Public consultation on the revised wind energy development guidelines

Joint consultation response prepared by the following group of acousticians:

Figure 1 – Example of a typical set of day and night prevailing background noise curves

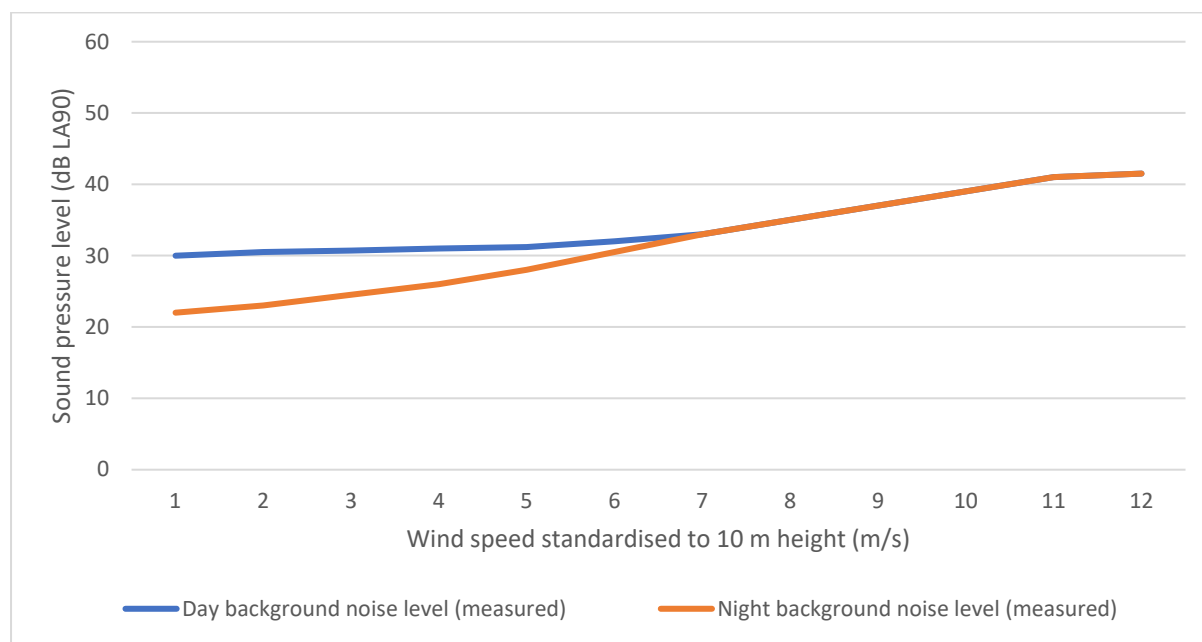
- 4.1.2 The draft guidelines require background noise to be quantified only using data acquired during the night-time hours, with corrections of 5 and 10 dB(A) applied to derive evening and day-time background noise levels, respectively. Given that monitoring will be undertaken during the daytime and evening periods anyway, it does not make sense to assume these daytime and evening background sound levels, as opposed to using the actual data from these periods. The draft guidelines try to provide justification for this at page 164, stating “*noise during the night-time period is critical in determining the overall noise level and consistency with the WHO conditional recommendation,*” however the proposed limits are not the WHO conditional recommendation so this is not relevant. In the next paragraph it discusses the difficulty in measuring wind turbine noise during the day, but at this point the discussion is about background noise (as opposed to operational noise) and there is no problem in measuring background noise during the day or evening.

- 4.1.3 If the argument is that the limit should be relaxed in the evening and day-time then that could be applied but as drafted the recommendation appears to be based on increased background levels during these periods that may well not occur in practice.

- 4.1.4 The proposed corrections for daytime and evening background noise levels assume that the increase in background noise during daytime or evening changes at the same rate with increasing wind speed as at night, however, this is not typically the case. An example of this can be seen in Figure 1, which illustrates the noise environment that may be found at a location where daytime activity (for example a busy road) may be the dominant sound source at low wind speeds. In this example it is not until 6 m/s that wind induced noise starts to have an effect on the measured noise levels. At night-time however, activity has died down and noise levels are therefore more influenced by changes in wind speed. It should also be noted that at higher wind speeds, noise levels for both daytime and night-time often converge as wind induced noise is the dominant sound source.

Figure 2 – Example of ‘assumed’ background noise curves derived using the draft guidance

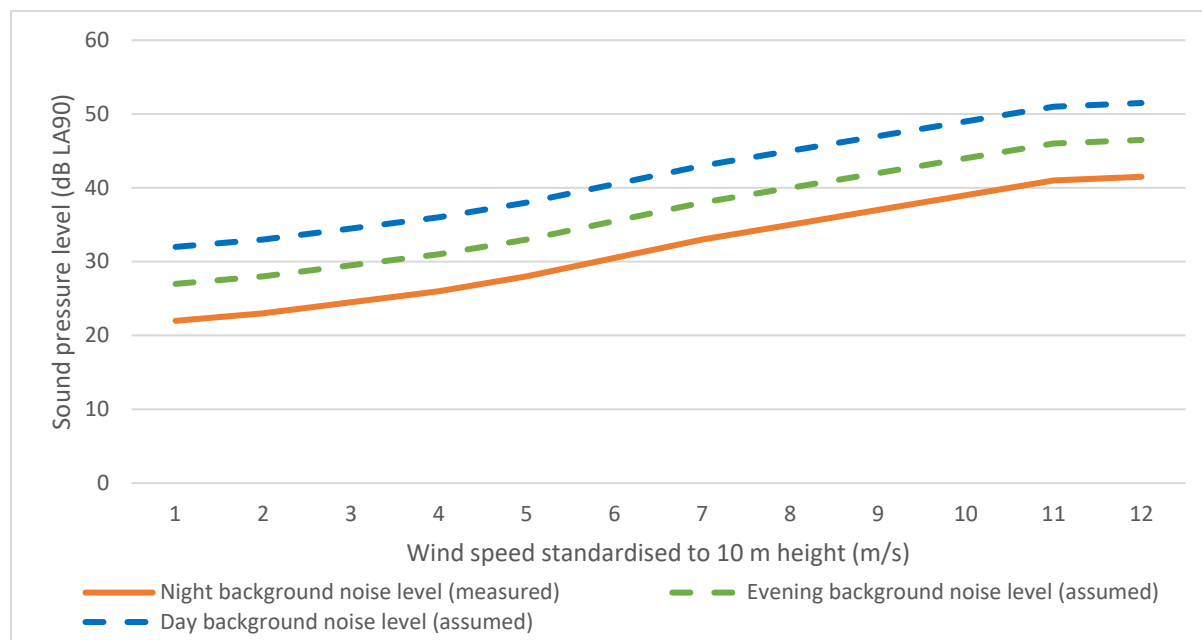
4.1.5 Figure 2 presents an example of background noise curves which may occur if the method used in the draft guidelines was adopted. In this example it can clearly be seen how the ‘assumed’ background sound levels for evening and day time periods may be overestimated, particularly at higher wind speeds.
